General Bid Bulletin No. 14
17 June 2021

RESPONSES TO CLARIFICATIONS

IFB No. 21-058-5; South Commuter Railway Project for Package Number CP S-03b; Civil Engineering, Tunnel and Building Works for Approximately 6.1km Railway with 4.7km of Underground Railway and 1.4km of At-Grade Railway, Including FTI Station and Tunnelling Works to Connect to MMSP Senate Station

NSRP-DWG-FTI-ST-4641

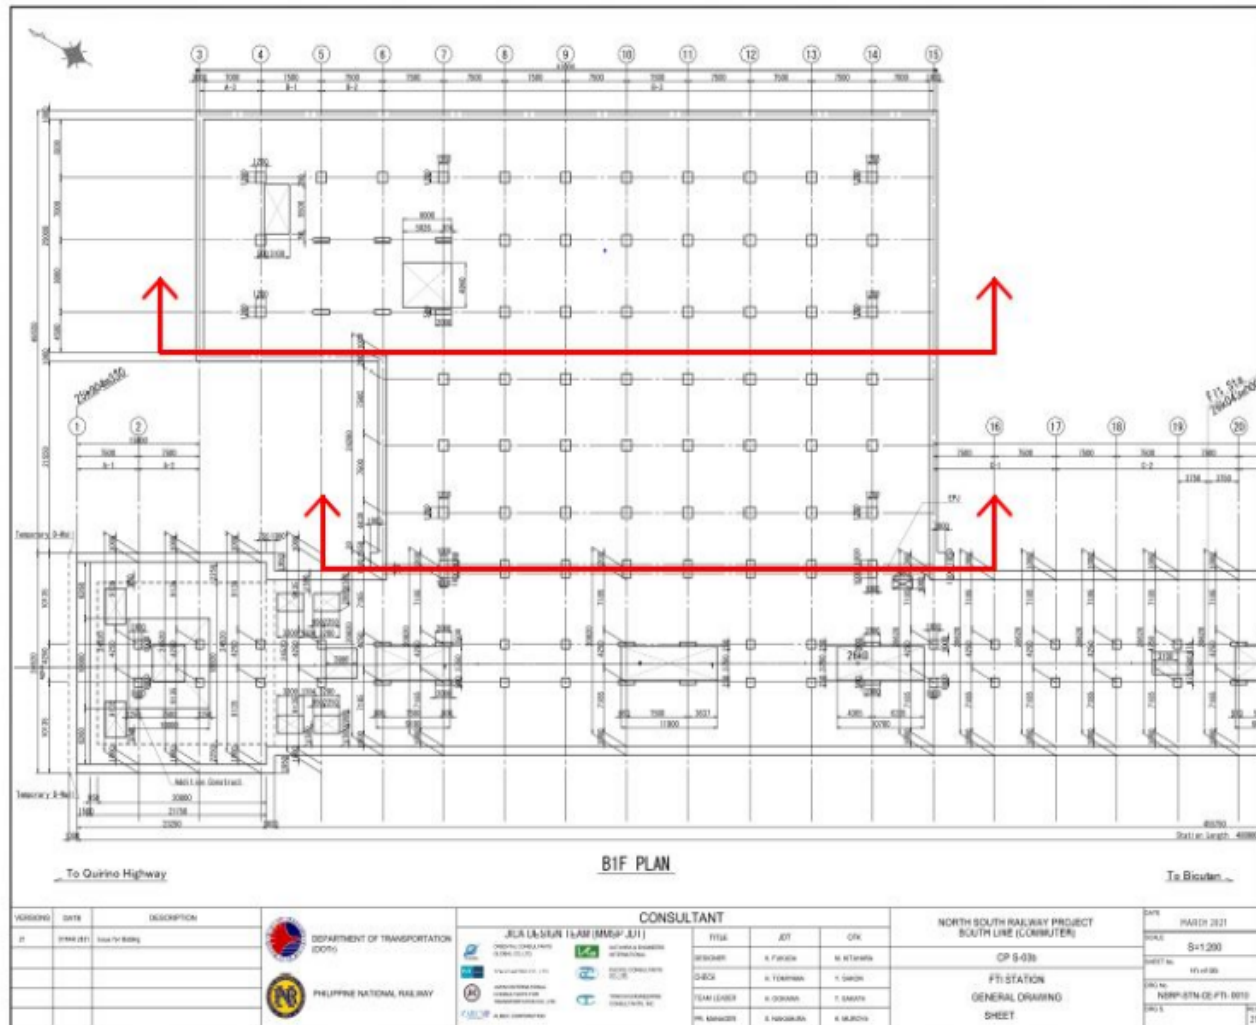
33	Volume 2 Package 03b Detailed Design Structural Drawings		N/A	N/A	N/A	Column PC1 of West Station Plaza doesn't have reinforcement details. Please clarify.	Column PC1 of West Station Plaza details has been reflected in NSRP-DWG-FTI-ST-4641 rev 21.2 issued 20 May 2021. Revision 21.2 drawings are included in Bid Addendum 2.				
34	Volume 2 Package 03b Detailed Design Structural Drawings		N/A	N/A	N/A	Column C1 of West Station Plaza has conflict in reinforcement details. Please clarify. Please see Annex II for reference.	Column C1 of West Station Plaza details has been reflected in NSRP-DWG-FTI-ST-4641 rev 21.2 issued 20 May 2021. Revision 21.2 drawings are included in Bid Addendum 2.				
35	Volume 2 Package 03b Detailed Design Structural Drawings		N/A	N/A	N/A	No details for stairs and ramps of West Station Plaza. We request details for this.	For stair details, please refer to NSRP-DWG-FTI-ST-4651 and 4652 rev 21.2 issued 20 May 2021. For ramp details, please refer to NSRP-DWG-FTI-ST-4641 to be submitted with Bid Addendum 3.

Based on the drawing, the main rebar is 12 and has ties.
